**Re: Panda Express**  
**2040 Gibson Blvd. SE**  
**Traffic Circulation Layout**  
Engineer's Stamp 09-12-23 (M15-D021F)

Based upon the information provided in your submittal received 09-28-23, the above referenced plan cannot be approved for Building Permit until the following comments are addressed:

SITE PLAN

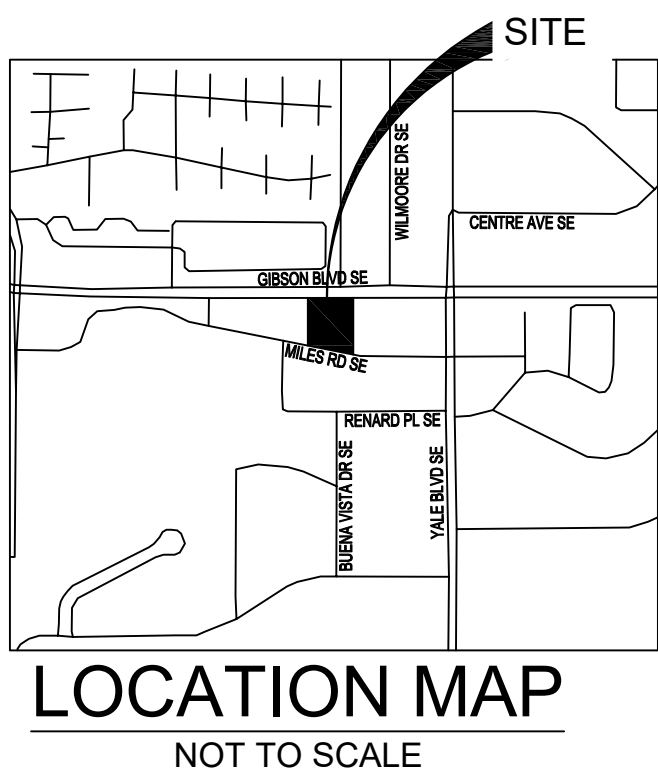
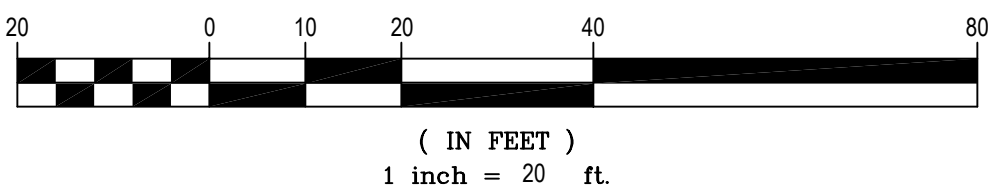
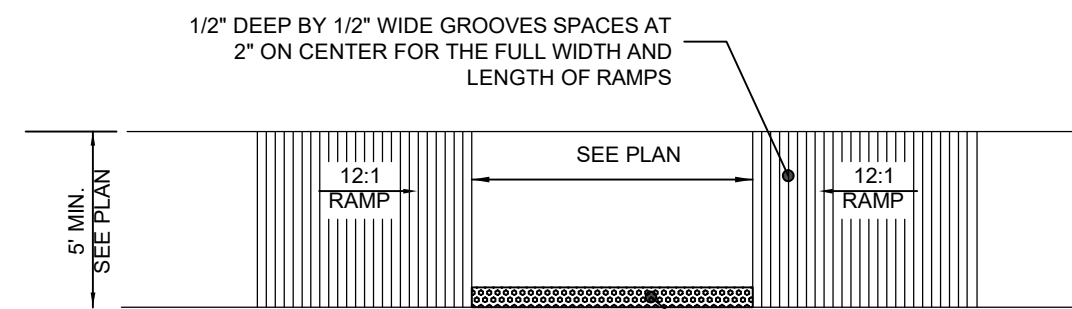
1. List the number of Motorcycle and Bicycle parking spaces required by the IDO.
2. Identify all existing access easements and rights of way width dimensions.
3. Identify the right of way width, medians, curb cuts, and street widths on Gibson Blvd. and Miles Rd.
4. Please provide a copy of Shared access agreement.
5. Show on the site plan the drive-thru lanes width.

Albuquerque

NM 87103

13. Refuse vehicle maneuvering shall be contained on-site. The refuse vehicle shall not back into the public right of way.; provide a copy of refuse approval.

HANDICAP PARKING DETAILS

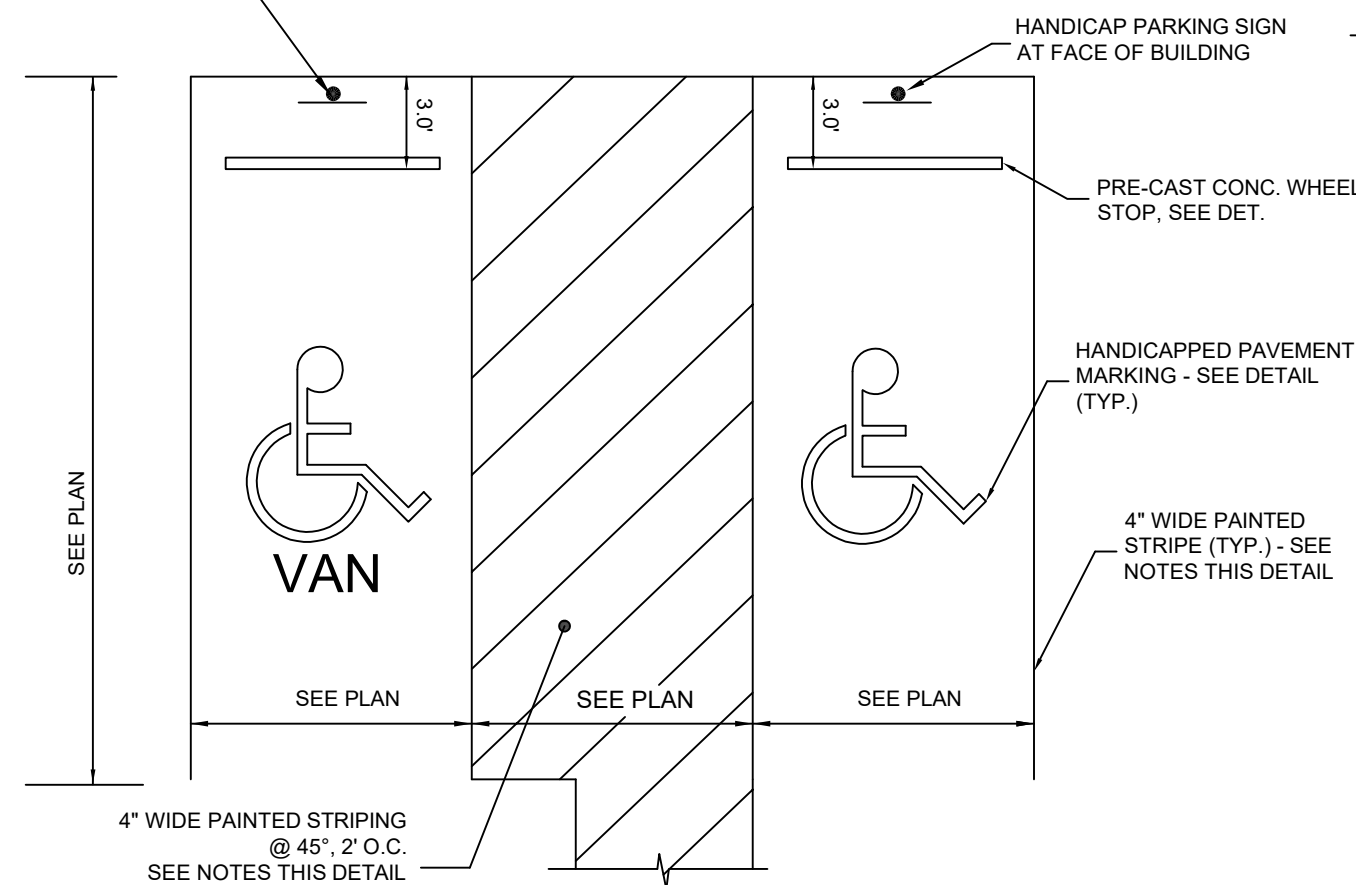
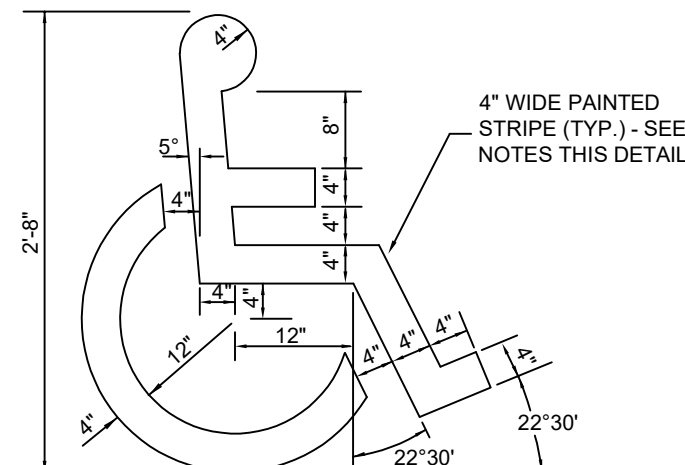
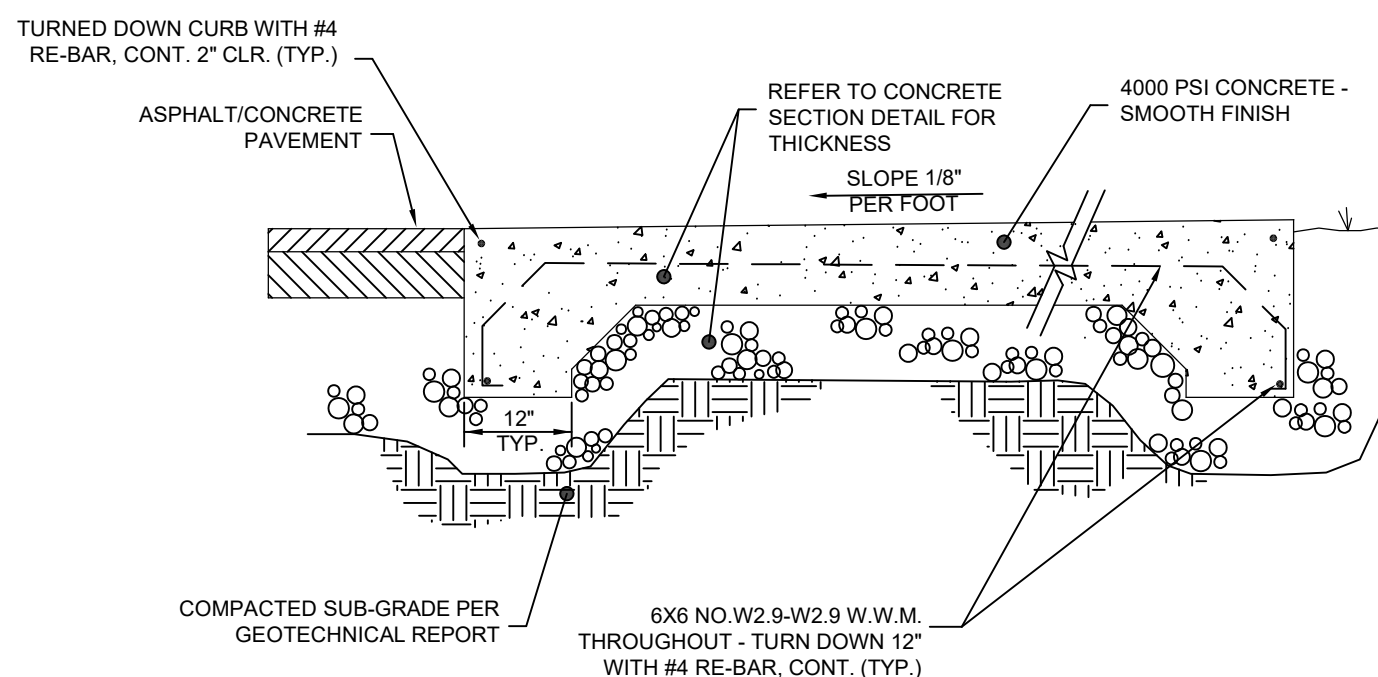
6. The ADA accessible parking sign must have the required language per 66-7-352.4C NMSA 1978 **"Violators Are Subject to a Fine and/or Towing."** Please call out detail and location of signs.

7. The ADA access aisles shall have the words **"NO PARKING"** in capital letters, each of which shall be at least one foot high and at least two inches wide, placed at the rear of the parking space so as to be close to where an adjacent vehicle's rear tire would be placed. (66-1-4.1. B NMSA 1978)
8. Please revise sheet C03.2, ADA ramp details. Minimum sidewalk width is 6 ft.
